MEMORANDUM

RE: 207 Granite Street (MAJ-26-0003) Engineering 3rd Review

LOTS 13 - 18, BLOCK 8
207 GRANITE STREET
FRISCO, COLORADO

A-2

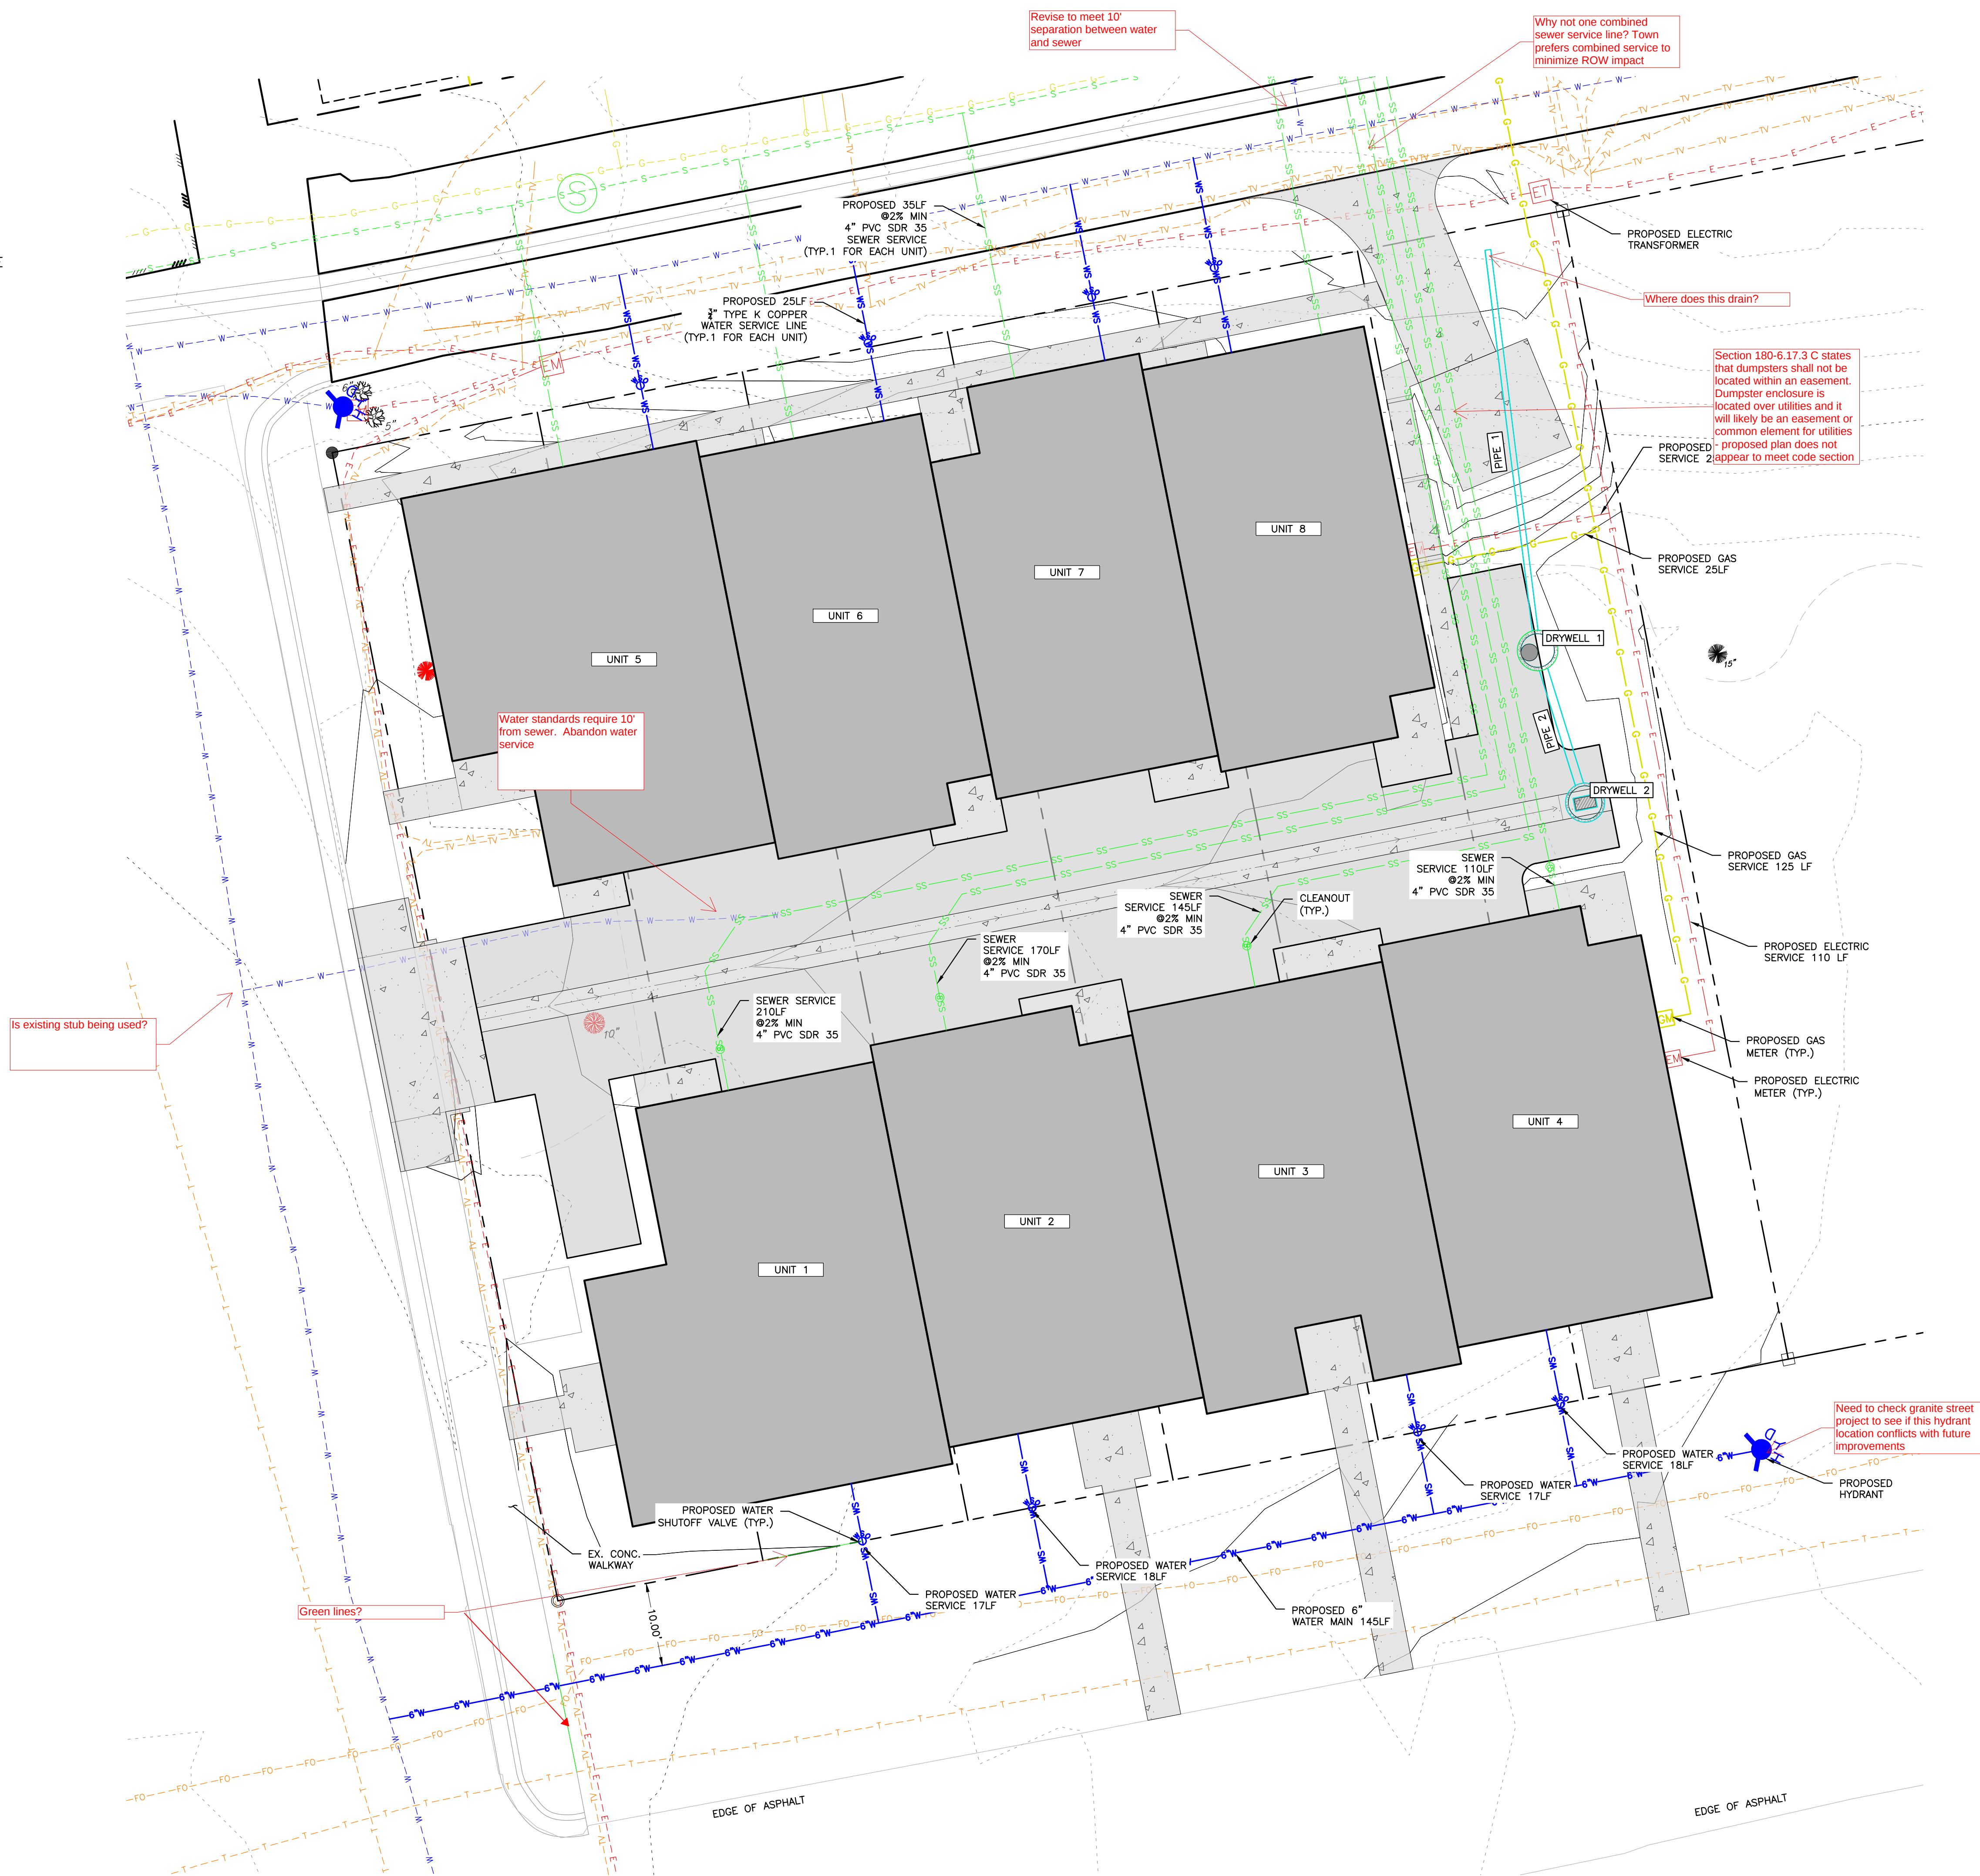
- **Access from 2nd Avenue.** A driveway connection is proposed to 2nd Avenue. Section IV-D-j of the Frisco Street Design Standards states, *“No driveways will be allowed onto collector or major arterial streets unless no other access to the lot exists”*. Because an alley is located adjacent to the site and provides an alternative means of access, the proposed driveway does not comply with this requirement.

- **Separate Dumpster Access:** A second driveway is proposed to serve the trash dumpster enclosure. Section IV-D-m of the Frisco Street Design Standards states, *“Dumpster enclosures shall be accessed through the same driveway allowed for access to the property.”* The proposed separate access does not meet this standard.

- **Dumpster Driveway Alignment:** The proposed dumpster access does not intersect the alley at a ninety-degree angle. Section IV-D-g of the Frisco Street Design Standards states, *“All driveways shall intersect the access street at ninety (90) degrees.”* As proposed, this requirement is not satisfied.

- **Internal Driveway Classification:** The internal access drive does not meet the Town's roadway standards. Pursuant to Section 180-9.3 of the Town Code, *“If an access way serves more than four residences, it shall be classified as a roadway rather than a driveway and must meet the Town's standards and requirements for road construction.”* Based on the proposed development, the access appears to meet the definition of a roadway and would therefore be required to comply with applicable Town roadway standards.

Submission of a waiver request does not imply staff support or Town approval. As shown in the redlines below, staff has identified a potential alternative access configuration from the alley that appears to be feasible. Because alley access is generally preferred as a means of preserving on-street parking capacity along public streets and improving pedestrian and vehicular safety by reducing driveway conflicts, the Town may not support or approve waiver requests associated with the proposed access from 2nd Avenue, the separate dumpster access, or the noncompliant dumpster driveway alignment when a feasible alley-access alternative exists. The applicant is strongly encouraged to evaluate modifications to the site plan that utilize the alley and otherwise achieve compliance with these standards prior to pursuing waiver requests.

- The site plan proposes sidewalk connections to Granite Street. These connections will lead pedestrians to the roadway (safety concerns), reduce snow storage, and require demolition of the concrete during the future project. Instead, a parallel sidewalk leading to 2nd Avenue should be added close to the property line, within the Granite Street right-of-way to address the concerns above (see redlines).
- The proposed fire hydrant in Granite Street will need to be reviewed for conflicts with proposed Granite Street changes and the location may need to be modified after further review.

- Trees are proposed in many of the snow storage areas. Per Section 180-9.3, “snow storage areas may be combined with required landscaping if the landscaping is designed to be compatible with large amounts of snow”. Many of the trees shown do not appear compatible with large amounts of snow.
- Many of the proposed tree trunks are located in the right-of-way and need to move outside the right-of-way

- The architectural site plan is not consistent with the civil site plan and needs to be updated to match.
- Water standards require 10' of separation between water and sewer. An existing water stub is within 10' of a proposed sewer line and a water and sewer service in the alley are within 10'.

- Section 180-6.17 of Town code states that “dumpster locations shall not be located within any utility easement”. The proposed dumpster location is located above several sewer lines and appears to not meet this code section.

- Four parallel sewer services are proposed into the Town alley. It is preferred to combine into a single main to minimize impacts and encroachment in the Town ROW.

- Town code requires detention of the 25-year storm to historic flows. Two drywells are proposed, but the north portion of the site flows undetained. A drainage report or memo will be required to confirm that offsite flows are not increasing above historic and the concentrated outflow near the alley will need to be analyzed.

- The contours on the north sidewalk exceed ADA standards.

- The proposed contours near the dumpster enclosure exceed IRC standards of 2:1 max slope. Grades shall be revised below 2:1, and it is recommended to grade below 3:1. Grades exceeding 3:1 require erosion blankets.

- Positive drainage required away from dumpster enclosure.
- The east guest parking space might not meet a turning movement for an AASHTO passenger vehicle. Turning movement to be analyzed and confirmed.

- Three series of steps are shown on the east sidewalk. While not required by code, applicant should consider consolidating stairs together.
